<b>Docket Number:</b>	25-OPT-02
<b>Project Title:</b>	Prairie Song Reliability Project
<b>TN #:</b>	270986
<b>Document Title:</b>	Save Our Rural Town Comments - Supplemental comment letter from Save Our Rural Town
<b>Description:</b>	N/A
<b>Filer:</b>	System
<b>Organization:</b>	Save Our Rural Town
<b>Submitter Role:</b>	Public
<b>Submission Date:</b>	6/24/2026 4:43:36 PM
<b>Docketed Date:</b>	6/24/2026

**Supplemental comment letter from Save Our Rural Town**

**Subject:** Supplemental Comments by Save Our Rural Town (SORT).

**Reference:** AB 205 Application Submitted for a Proposed Battery Energy Storage Project in Acton, CA.  
Docket Number 25-OPT-02.

Figure 1. MEIR Locations Corresponding to Different BESS Burn Locations.

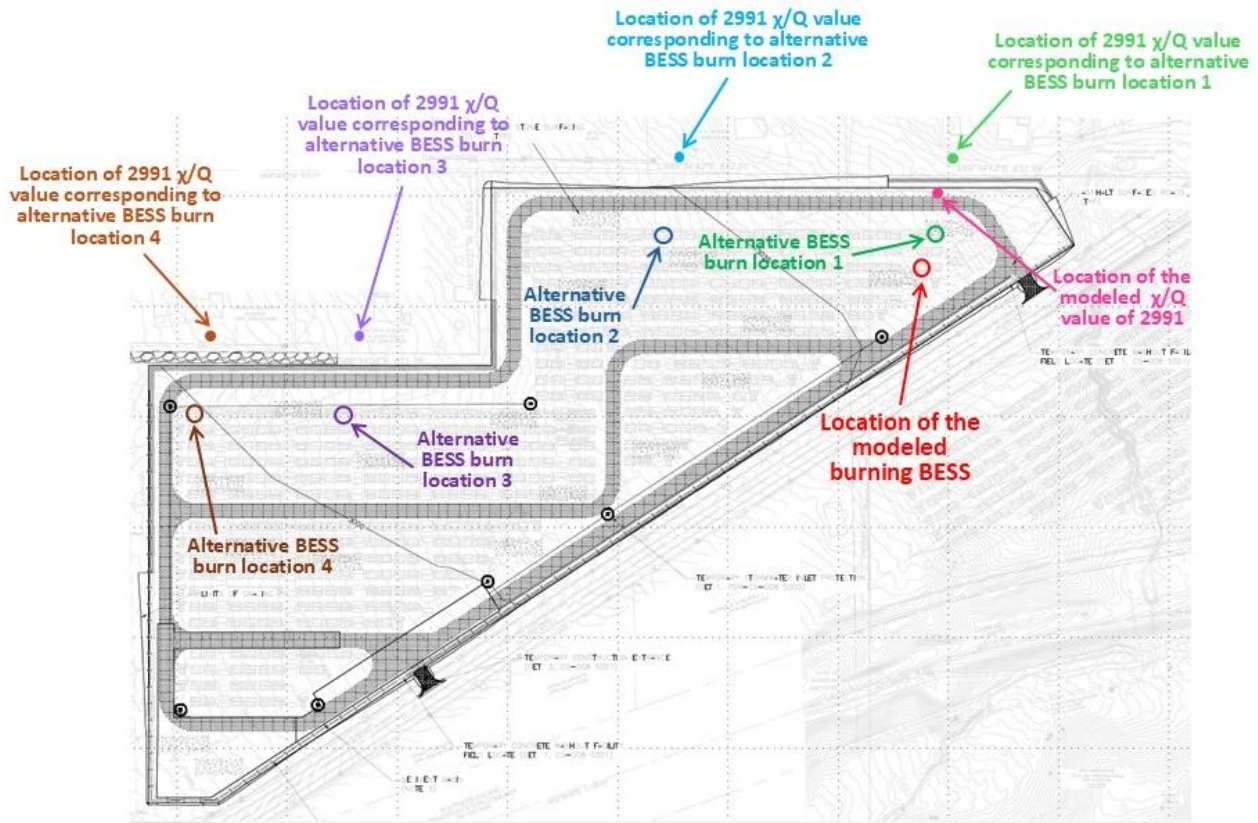
yields an HF concentration of 508.3  $\mu\text{g}/\text{m}^3$  which is more than *double* the REL threshold established for the project. Furthermore, if a more appropriate BESS location had been modeled as the burn site, this 2991  $\chi/\text{Q}$  value and corresponding 508.3  $\mu\text{g}/\text{m}^3$  HF concentration level would have occurred outside the project boundary and in the front yard of a surrounding residence. Figure 1 illustrates this point:

- Had Alternative BESS Burn Location #1 just north of the modeled BESS been selected as the burn site, the resulting 2991  $\chi/\text{Q}$  value and corresponding 508.3  $\mu\text{g}/\text{m}^3$  HF concentration would have occurred in the front yard of the Benitez home;

- Had Alternative BESS Burn Location #2 to the north and west of the modeled BESS been selected as the burn site, the resulting 2991  $\chi/\text{Q}$  value and corresponding 508.3  $\mu\text{g}/\text{m}^3$  HF concentration would have occurred in the front yard of the Bevaro home;

- Had Alternative BESS Burn Location #3 to the west and south of the modeled BESS been selected as the burn site, the resulting 2991  $\chi/\text{Q}$  value and corresponding 508.3  $\mu\text{g}/\text{m}^3$  HF concentration would have occurred in the front yard of the Quevedo home.

- Had Alternative BESS Burn Location #4 at the west end of the BESS yard been selected as the burn site, the resulting 2991  $\chi/\text{Q}$  value and corresponding 508.3  $\mu\text{g}/\text{m}^3$  HF concentration would have occurred found in the front yard of the Ramirez home.

SORT also recently noticed that the developer's AERMOD analysis reports an 8-hour  $\chi/\text{Q}$  value of 1653.19 at UTM coordinates 394894.77 east and 3816459.27 north<sup>15</sup>; this is the same location where the 1-hour  $\chi/\text{Q}$  value is reported to be 2991. Reconciling this 8-hour  $\chi/\text{Q}$  value of 1653 with the developer's alleged 0.17 g/s HF emission rate yields an average 8 hour HF concentration of 281  $\mu\text{g}/\text{m}^3$  which also exceeds the REL established for the project. And, had a more appropriate BESS location been selected for the AERMOD modeling effort, this 8-hour 1653  $\chi/\text{Q}$  value and corresponding 281  $\mu\text{g}/\text{m}^3$  HF concentration level would have occurred outside the project boundary and in the front yard of a surrounding residence.

At the very least, these facts demonstrate that 1) the project will generate HF concentrations on surrounding residential properties which substantially exceed

adopted safety thresholds; and 2) that the developer's conclusions regarding 1-hour and 8-hour MEIR exposures are substantially deficient. Moreover, because the developer underestimates the project's HF emission rate by at least an order of magnitude (as SORT has previously explained), actual offsite HF concentrations that will occur when a BESS unit ignites will substantially exceed established safety levels at great distances from the project site.
